From: Christopher Ciz
Sent: Monday, July 14, 2014 3:02 PM
To: All Dirs All Rgns - PT; All Dirs All Rgns - SR
Subject: MAZDA DEALER NOTICE - SERVICE BULLETIN RELEASE

05-008/14 – MULTI-MODEL (6 SPEED SKYACTIV M/T) - HARD TO SHIFT INTO 3RD GEAR

Subject: HARD TO SHIFT INTO 3RD GEAR	Bulletin No: 05-008/14
	Last Issued: 07/14/2014

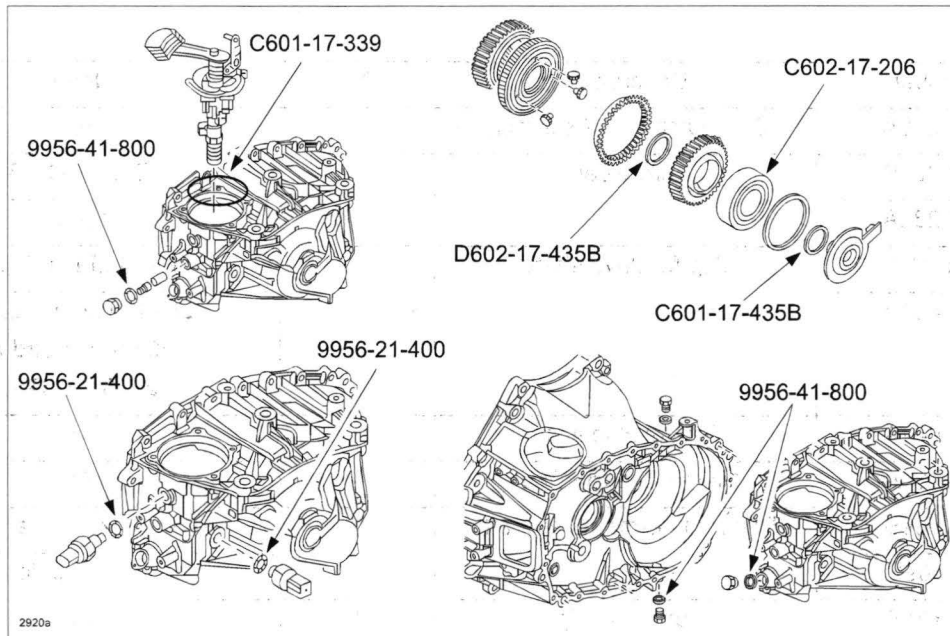
This is caused by the friction coefficient between the 3/4 clutch hub and the sleeve increasing. A surface treatment has now been added to the 3/4 clutch hub to decrease the friction coefficient.

1. Verify customer concern.
2. Remove the transaxle. Refer to MS3 online instructions or the Workshop Manual section 05-15.
3. Replace the 3/4 clutch hub with a modified one and the 3rd gear with a new one (listed in the Parts Information). Refer to the C66M-R 6-speed SKYACTIV Manual Transaxle Workshop Manual.
